NOVI CRESCENT PHASE II JSP14-33

Consideration of the request of Versa Development for approval of Preliminary Site Plan and Stormwater Management Plan. The subject property is 1.99 acres in Section 15 of the City of Novi and located on the west side of Novi Road, south of the freeway interchange in the TC, Town Center district. The applicant is proposing to demolish the existing Melting Pot restaurant and construct an approximately 12,800 square foot building consisting of retail and restaurant space.

Planning Review

Preliminary Site Plan

MARK-UP BY CLEARZONE, 6-3-14

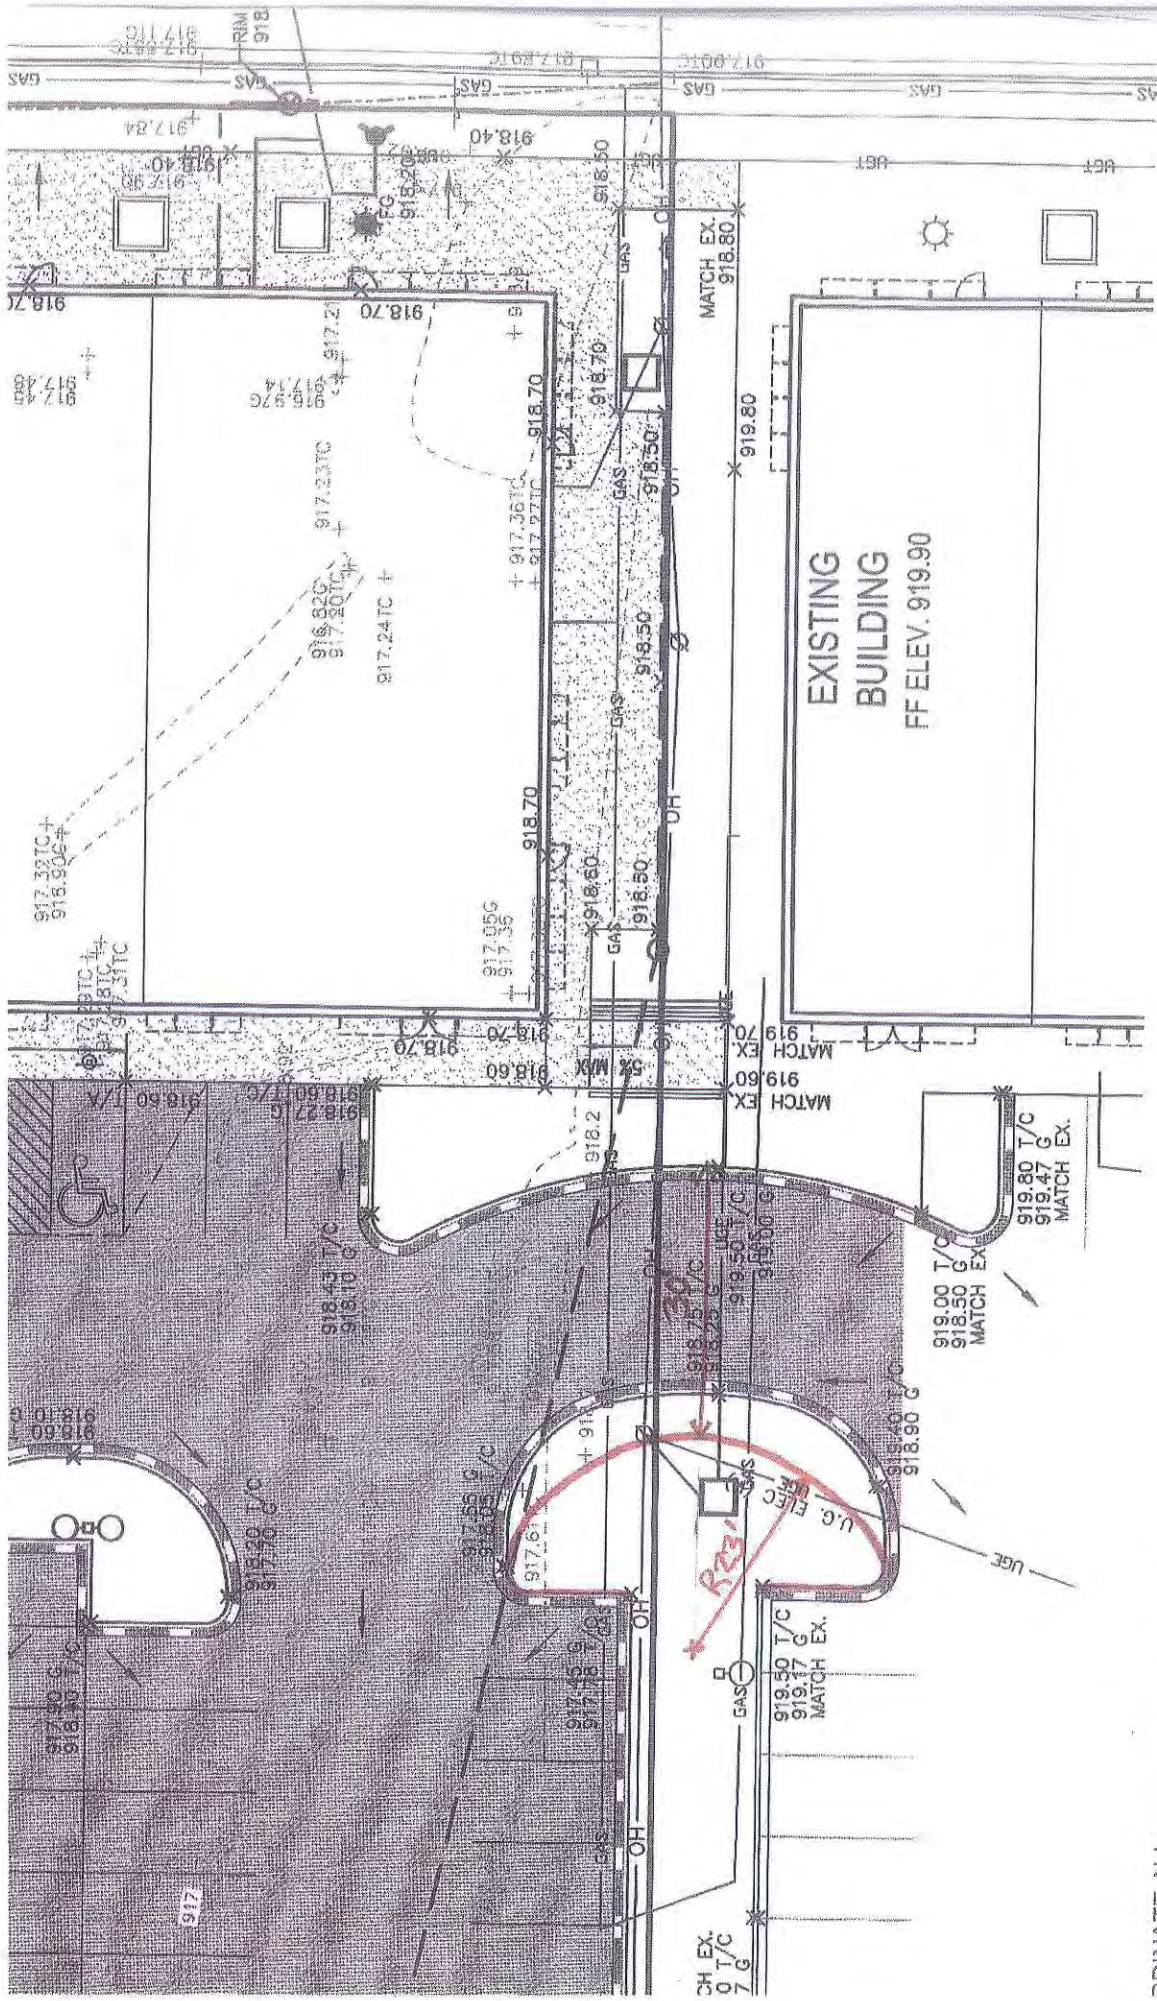
8. **To improve internal circulation by large trucks, including that which may occur between the two Novi Crescent sites, the cross-access connection between the two sites should be enlarged as shown on our attached site plan mark-up.** This requested circulation improvement would not lose any parking spaces on either site.

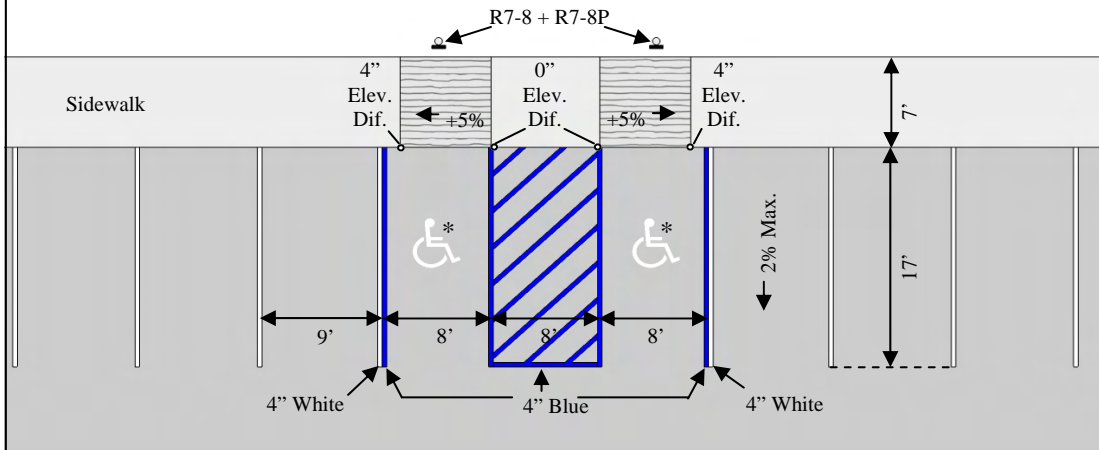
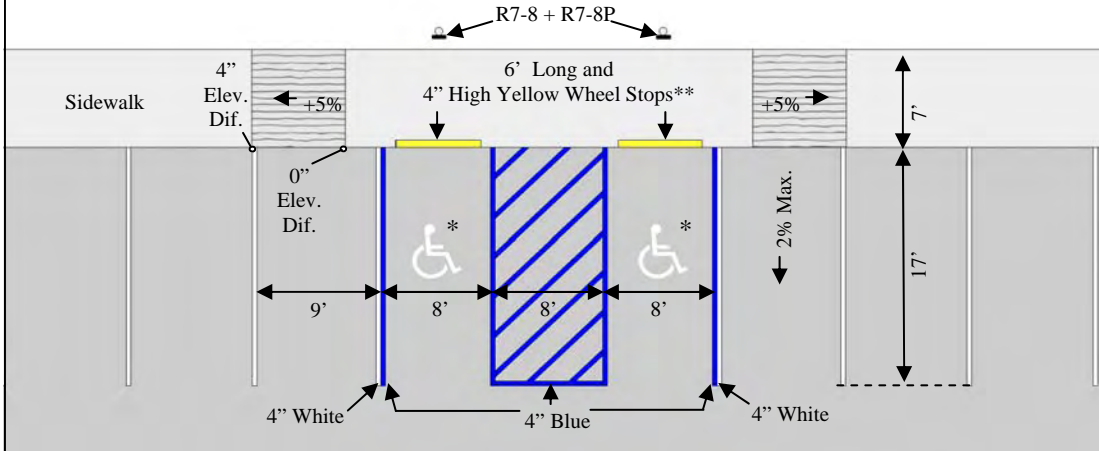
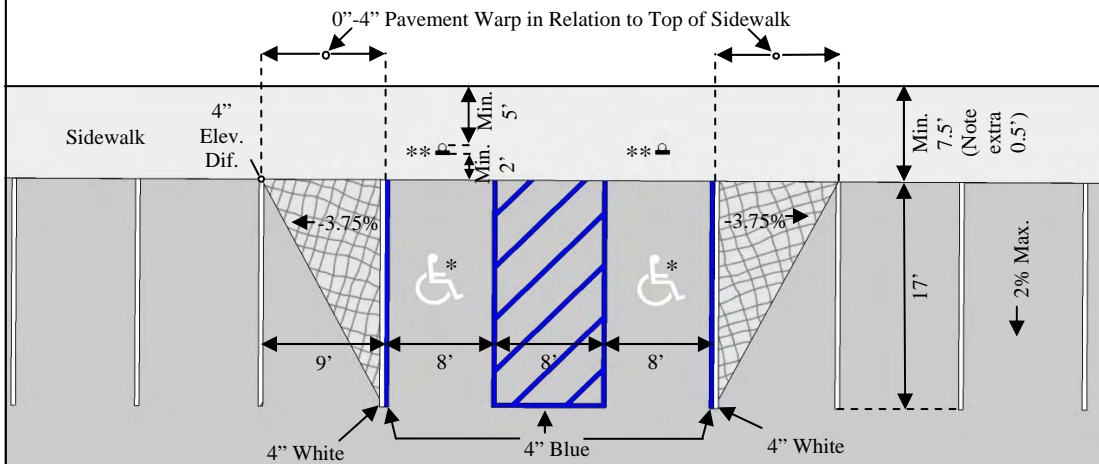
10. **Neither the Site and Paving Plan (sheet 5) nor the Preliminary Grading Plan (sheet 6) clearly and accurately indicates how the transition from the 4-inch-high walk to the flush walk near the barrier-free parking spaces would be accomplished. The dashed diagonal lines in the paved area appear to indicate that the pavement would be warped up to make it flush with an overall flat walk (per attached Alternative C); however, if this is the case, the two dimensions reading '4" High Curb' extend 9 ft (or one parking space) too close to the dedicated spaces. In our interpretation, these two dimensions should extend over the northernmost 11 parking spaces (not 12 spaces) and southernmost four spaces (not the 3rd, 4th, and 5th spaces from the south end). The pavement warping over the first adjoining undedicated space will provide the necessary parking stop in the outer wheel track of a parking vehicle. No other type of parking stop in those spaces is required or desirable.**

- b. **The detail for integral concrete curb and sidewalk should dimension the curb/walk height as 'Varies (4" Max)', not 6" (Max).**
 - c. **Given their location within the sidewalk, the accessible parking signs should be higher. The height of the VAN ACCESSIBLE (R7-8P) sign should be dimensioned 6'-3" (Min), not 5'-0", and the height of the RESERVED PARKING (R7-8) sign should be dimensioned 7' (Min). (Given that the lower sign's actual panel dimension is 6", it should be possible to achieve an even more desirable mounting height of 6'-6".) We also recommend that the reinforced base (or bollard) rise to a height of 4', not 3'.**

4. No response required.
5. No response required.
6. ADA pedestrian ramp on south side of driveway will be noted and shown on the plans.
7. The maximum size of on-site delivery truck will be shown on Final Site Plan submittal along with fire truck route.
8. The cross access driveway was revised with the Preliminary Site Plan submittal to be a straight access and therefore should improve internal circulation by large trucks.
9. A detail for bollards will be shown on the Final Site Plan submittal.
10. Labels have been revised to more accurately depict the curb transition.
11. Elevations have been revised on Sheet 6.
12. Hatching pavement markings will be shown to scale on Final Site Plan submittal.
13. Loading Zone sign locations have been revised.
- 14a. Reverse Curb Detail will be revised.
- 14b. Integral Curb and Sidewalk Detail will be revised.
- 14c. Sign Detail will be revised.
